Planning Commission

STAFF REPORT

Agenda Item #6a: Site Plan Review for Seventh Day Adventist Church Parking Lot Improvement

Applicant: Gary Schacht
Property Owner: Seventh Day Adventist Church
Property Address: 622 10th Ave W.
Parcel No: 201-04381-0000
Zoning District: Single and Two-Family Residential (R-2)
Staff Contact: Terri Erickson

Above is an earlier site plan showing proposed one-way traffic flow.

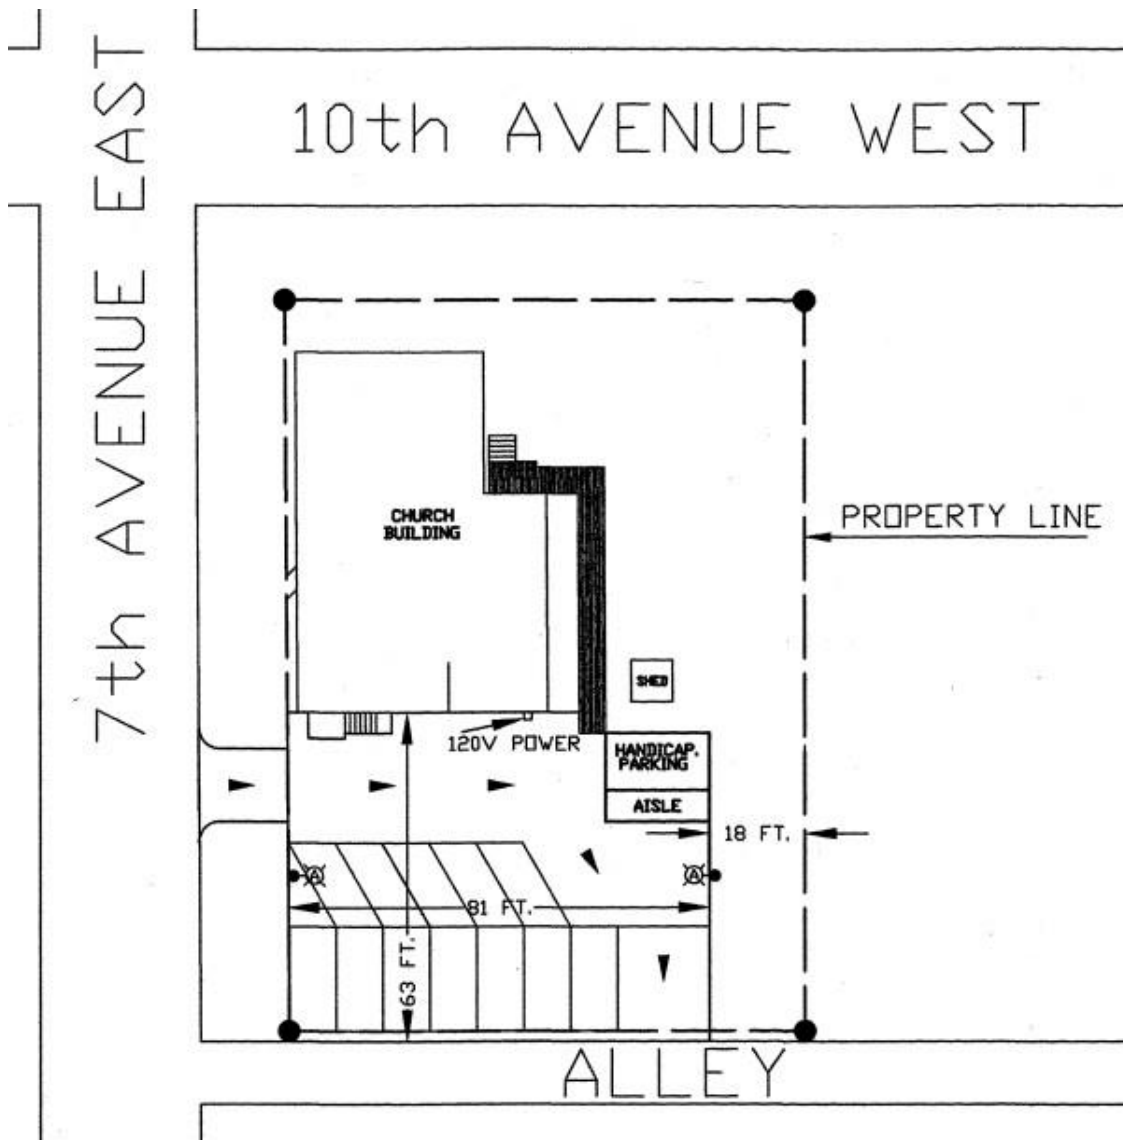
The church currently has a paved parking lot of approximately 4,100 SF. The original site plan submitted requested an additional 3,000 SF of parking on the north side of the existing lot. The applicant initially hoped to extend the lot up to 2 feet from the property line on the north side and connect to the alley on the east side. He was hoping to preserve the existing parking spot located in the ROW adjacent to the entrance drive to the south of the building. Upon review with public works, this request was denied and they were requested to remove all existing parking surface from the ROW. Planning and Development staff requested a more detailed site plan specifying the extents of the new and existing parking area and information showing traffic circulation and parking space identification. Concurrently, the neighbor to the north spoke with planning staff and Gary regarding his concerns about the expanded parking lot encroaching too close to his garage and the potential for snow piling up against it. Over the summer he attended a City Council meeting to express his frustration with the updated GIS parcel line generation and stated that he felt they were not compatible with original property lines and therefore allowing new development that is not accurate. He feels this affects his lot because his property lines, according to the current GIS mapping system, are pushed further to the north which now show his garage extending onto the adjacent church property.

In response, the applicant submitted a revised site plan showing proposed drive aisles and parking spots. He also pulled the proposed northern edge of the parking lot away from the north property 16 feet to help alleviate neighbor concerns. Upon review, staff recommended to meet in person to discuss the plans. Staff reviewed concerns with the proposed parking layout including dimensional requirements as well as the flow of traffic and pedestrians. A few alternate layouts were reviewed and staff discussed that a site plan review by the Plan Commission would be required. The applicant was given additional information on the process and submittals needed for this.

Above is the current site plan for which approval is requested.

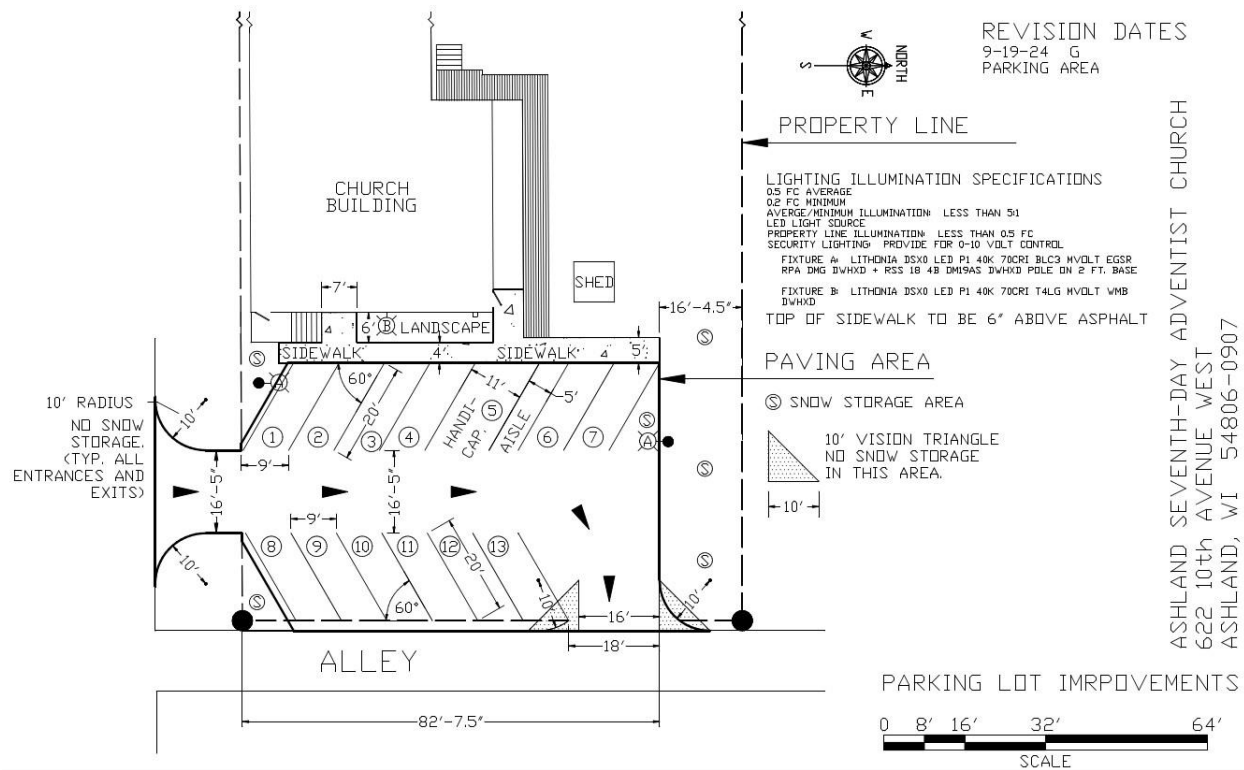
The final site plan submittal rearranges the one-way drive aisle to be centered between two parking rows. The handicap space provides direct access to the entry ramp and a pedestrian sidewalk runs along the entire length of the lot which creates a separation from the parking and drive area. Snow storage locations are noted as well as vision triangles and an area for landscaping adjacent to the building. There will be a curb cut at the ADA aisle to access the ramp. The revised parking layout provides 13 parking spots including one handicap spot. The applicant stated that the current lot accommodates up 14-15 vehicles. Therefore, the new lot will accommodate a couple less vehicles but provide for a new ADA handicap spot and striped parking.

Dimensions for all proposed parking and driveway areas conform to UDO standards.

The proposed development will have a one-way access to the site from a relocated driveway off of 7th St W. Vehicles will exit the parking lot to the alley and can go either north or south from here to connect back up to either 6th or 7th street.

The new layout has two rows of 60-degree parking that is accessed from a one-way drive through the property. It provides code compliant spaces for 13 vehicles with one space designated as ADA accessible. The owner stated that the original lot, which did not have parking lines, could fit up to 15 vehicles. This included a row of parking spots that was accessed from the alley. The existing layout does not include any ADA designated spots but did have one spot that was completely in the right of way. They are

losing 2-3 parking spots but will be gaining a designated ADA space with an access aisle.

The required off-street parking spaces for a religious institution is 1 per 4 seats or 1 per every 8 feet of pews. With these calculations, the required number of parking spots required for this church would be 22. The new parking plan is providing a total of 13 spots which is far under what would be approved for building of this type that was not constrained by lot size.

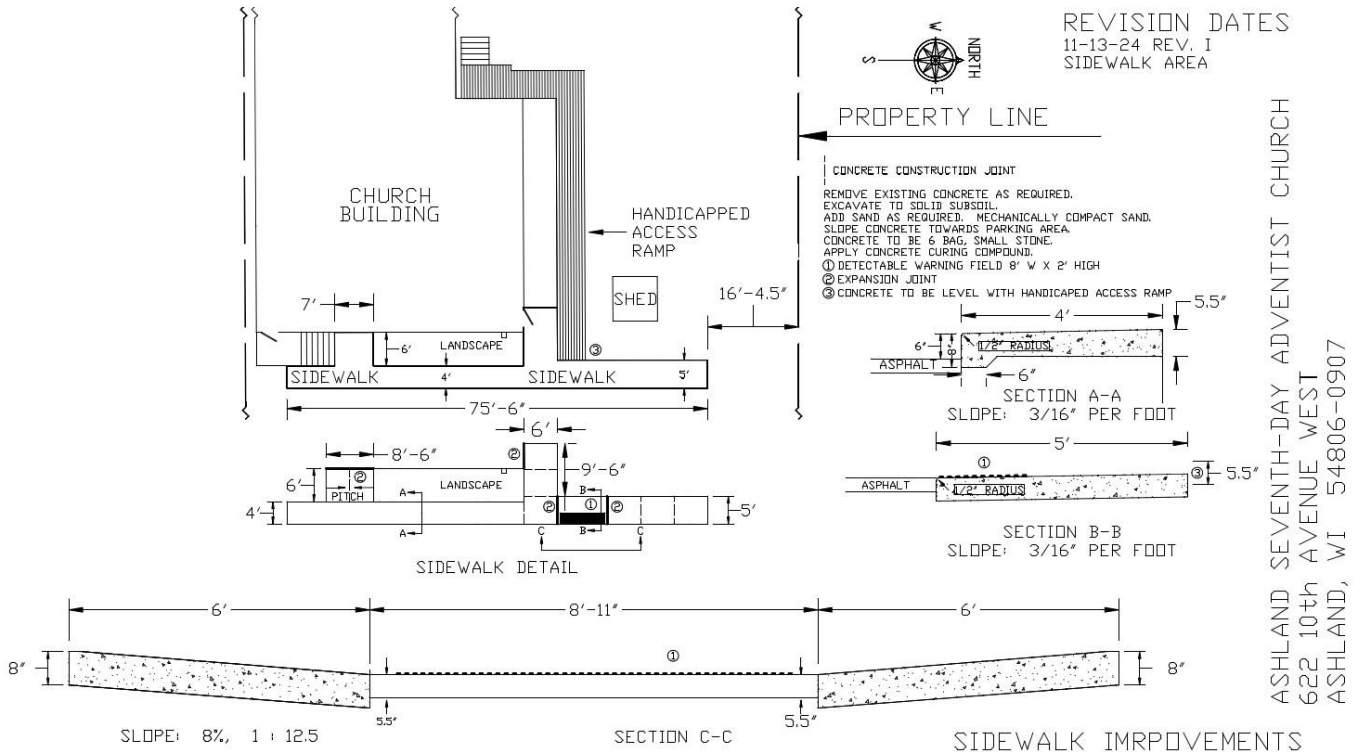
The ordinance states that *"A minimum five-foot setback shall be required between any new or reconstructed parking lot and any interior side parcel line."* The north edge of the parking lot is set back 16 feet 4 inches from the interior side parcel line on the north. This area also provides required snow storage space.

The ordinance states that *"In no case shall parking be less than fifteen (15) feet from a public right-of way, except in situations as determined by the Zoning Administrator or Designated Authorized Agent where an existing parking lot is being reconstructed and conformance with this section would drastically decrease the number of required parking spaces..."* In this case, existing conditions would waive the requirement for a fifteen-foot setback from the right-of-way. The existing lot is currently non-conforming being that it extends over the property line into the right-of-way along 7th Avenue and along the alley. Since the City is requiring the new lot to be within the property lines, the church will be losing 1-2 parking spots. Staff recommends allowing the reconstruction of the parking lot to extend up to the property lines on the south and east to accommodate as many parking spaces as possible while still meeting the needs for snow removal on the north side of the lot.

h. Lighting.

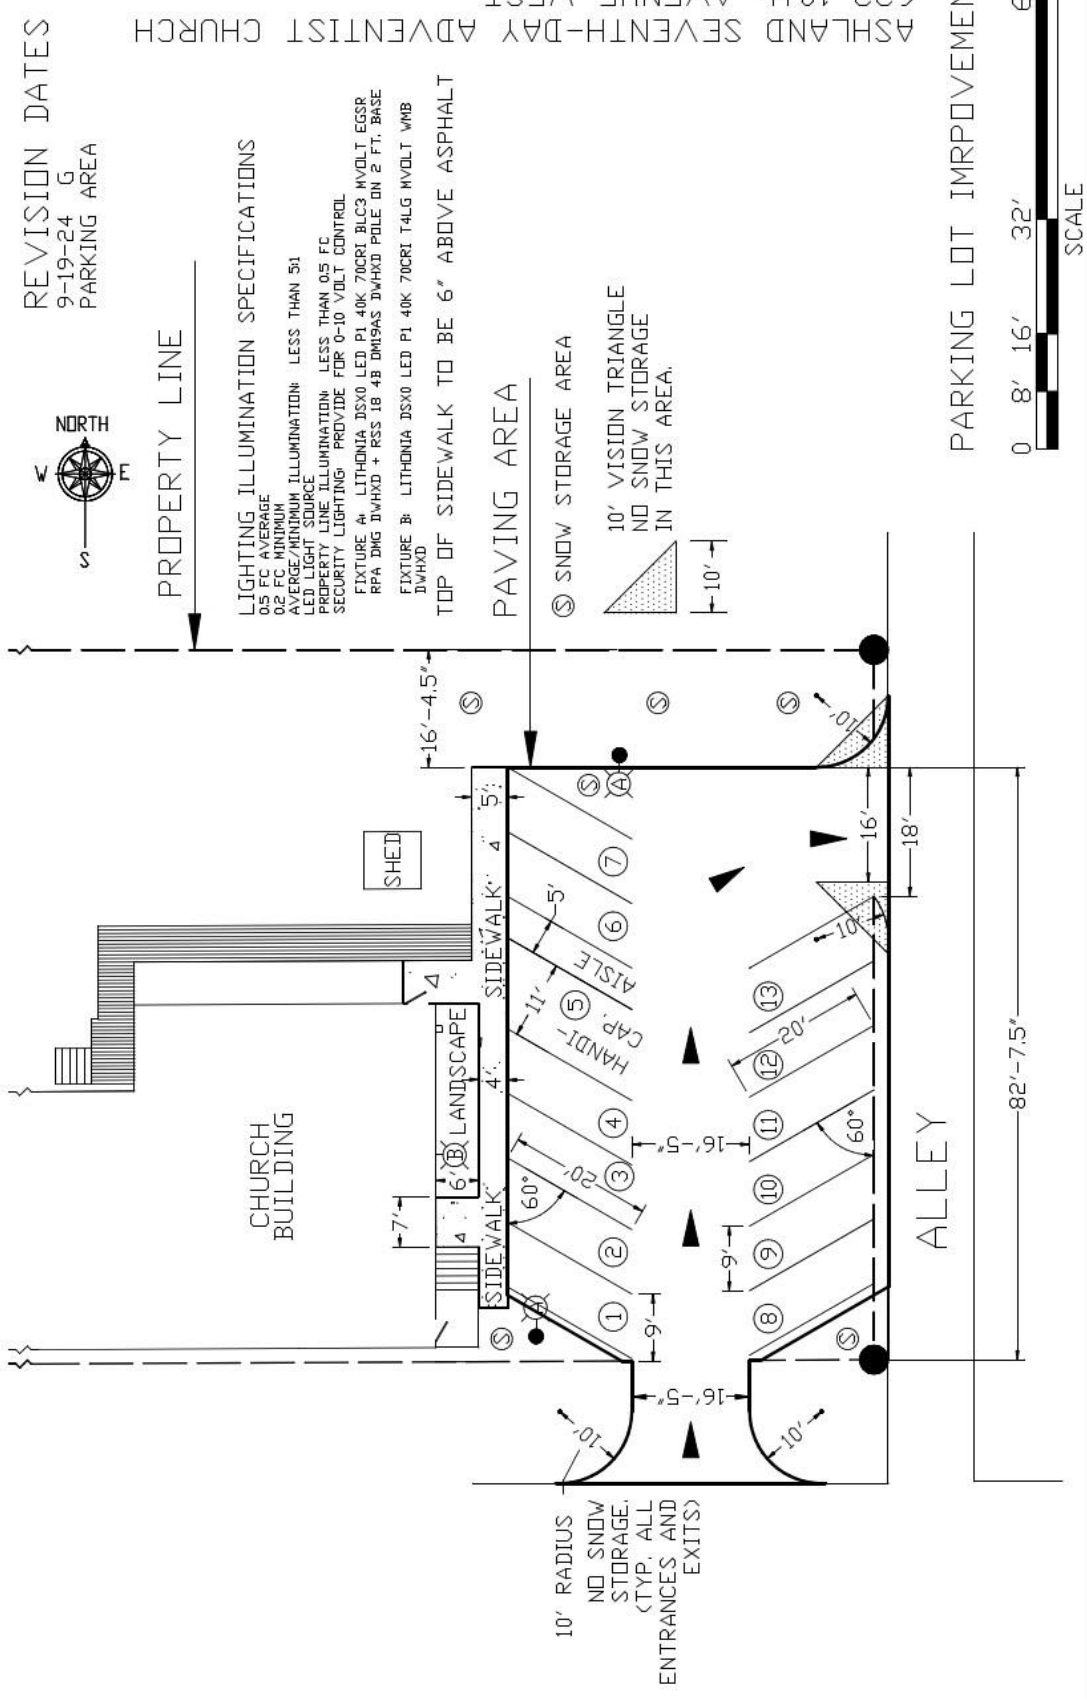
Any proposed exterior lighting requires the electrician to submit full exterior lighting plans to the City's Planning & Development Department for review and approval to ensure it conforms to all UDO standards. All exterior lighting must be full cutoff to direct light down and not up or out to adjacent properties. The applicant has already submitted a lighting plan that was reviewed by staff. The plan meets code based on staff's review. The minimum light levels meet the 0.2 footcandle minimum required by code and the ratio of average to minimum lighting is less than the maximum permitted by code. The neighbor to the north has expressed concerns regarding lighting. Staff verified that the light trespass at the property lines is less than the 0.5 footcandle maximum allowed by code. Additionally ordinance requires that exterior lights be extinguished or dimmed to 50% no later than 30 minutes after the close of business for the day or after the end of normal business hours for the majority of employees. Staff would recommend as a condition of approval that the property must follow this condition with the proposed exterior lighting. The applicant informed staff that the mounting height of the freestanding light fixtures will be 20 feet (18-foot pole with a 2-foot base). Staff recommends as a condition of approval a maximum mounting height of 20 feet for the light fixtures.

5. Snow storage must not extend onto the property of neighbors. If there is excess snow that does not fit in the designated areas it must be hauled off site or contained in the parking lot. No snow shall be pushed in a manner that it encroaches over any neighboring property line or builds up against any neighboring structures.
6. The applicant shall install any directional signage deemed necessary by the Department of Public Works.
7. The lighting system shall be extinguished or reduced to fifty (50) percent no later than thirty (30) minutes after operations for the day or evening cease. The maximum mounting height of the light fixtures shall not exceed 20 feet (18-foot pole on a 2-foot base).
